Machines	TASKI ergodisc omni, 1200
Subassembly	Chassis

Introduction electronic relay

Service Information

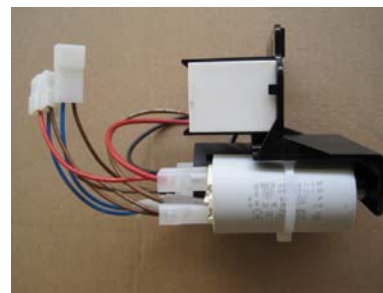
We repeatedly received input from the field that the capacitors breakdown. Investigations have shown that common reasons for these failures are voltage fluctuations (e.g. unstable power supply, extension cables, etc.) combined with short switch-on time of the machine. These two factors have a vital impact on the live expectation of the capacitors (mainly the start capacitor). The new electronic relay optimises the switching process between start- and operating capacitor, which will help to reduce the breakdowns.

Internal tests have shown that in case of a malfunction/breakdown of the relay, the other two components (capacitors) of the relay plate can also get damaged. In case of a service we recommend to exchange the complete electric panel. The electronic relay will not be introduced as spare part.

Description	Material number	Remark
Electric panel complete 220-240V	4130794 (14604-76)	New spare part number
